**SUBJECT:** Administrative Approval for Petition No. 97-62 Educational Facilities Group, Inc.

# EDUCATIONAL FACILITIES GROUP

**TECHNICAL DATA SHEET**  
ATTACHED TO ADMINISTRATIVE APPROVAL  
PETITION NO. 97-62  
AS FOR PUBLIC HEARING  
DATED: August 2, 2002  
BY: MARTIN R. CRAMTON, JR. *Martin R. Cramton, Jr.*

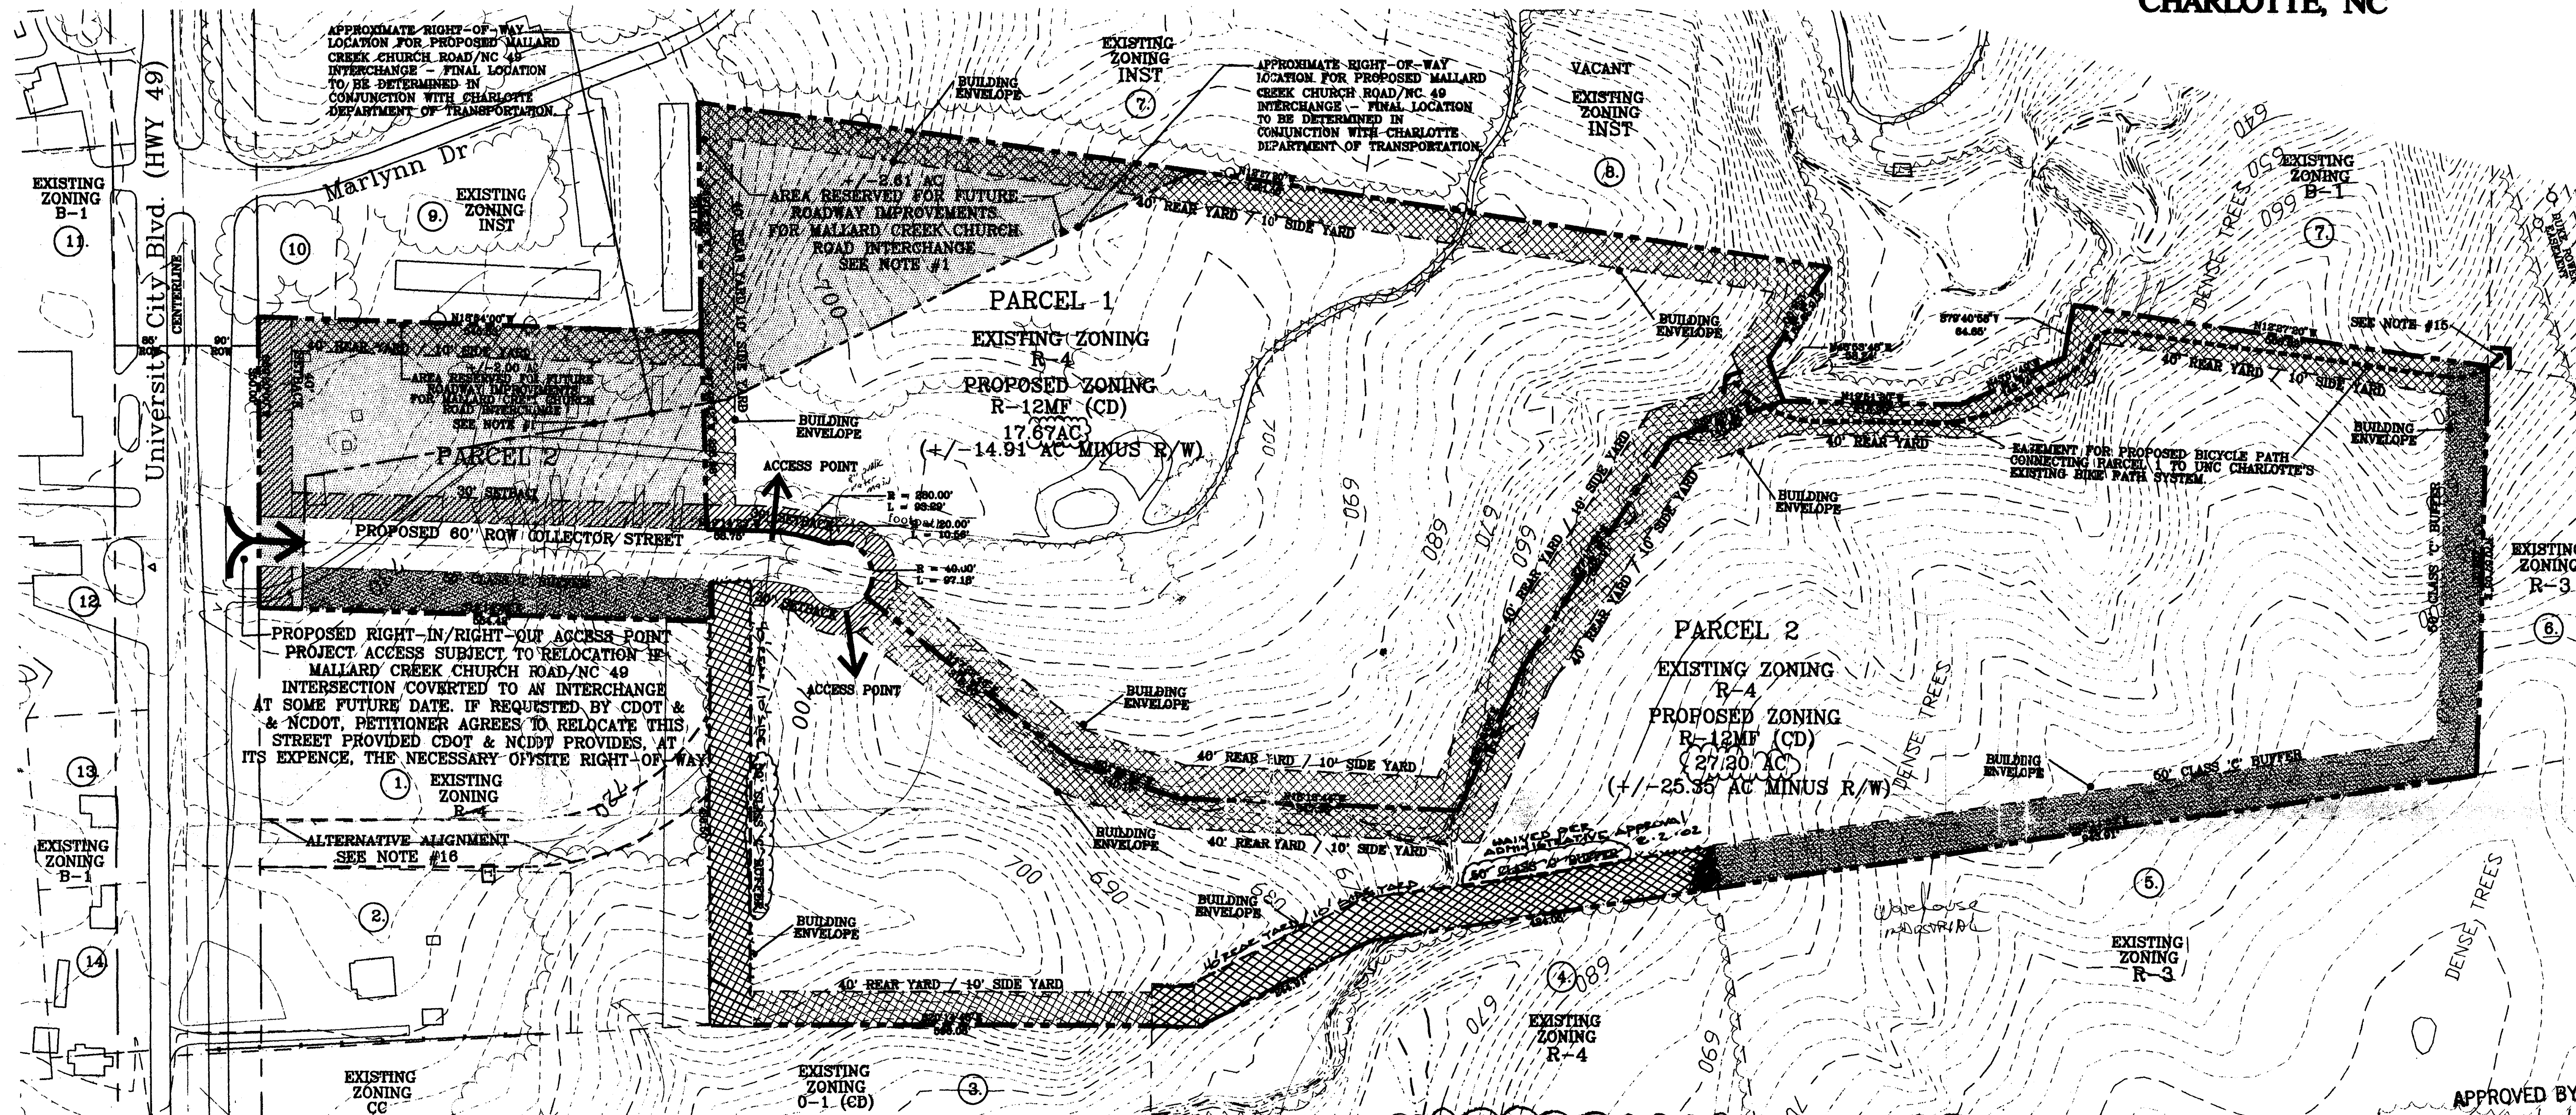
Attached is the revised plan for the above petition. The plan has been revised to show the elimination of portions of the buffer due to the rezoning of adjoining property and use changes on adjoining property. Since these changes do not alter the intent of the development and meets the requirements of the Charlotte Zoning Ordinance Section 6.206(2) Alterations to Approval for minor changes, I am administratively approving this plan. Please use this plan when evaluating requests for building permits and certificates of occupancy.

- As depicted on this site plan, certain portions of the previously required Class "C" Buffer within Parcel 2 have been eliminated based on an Administrative Approval authorized by the Charlotte-Mecklenburg Planning Commission on August 2, 2002. This Administrative Approval was authorized based on an analysis of certain changes that have occurred on adjacent properties that will satisfy buffer requirements in these areas along common property boundaries abutting the subject site. These changes are a result of development approvals or development activity that have occurred on adjacent properties since the effective date of when this petition (897-62) was approved on 9.15.97.
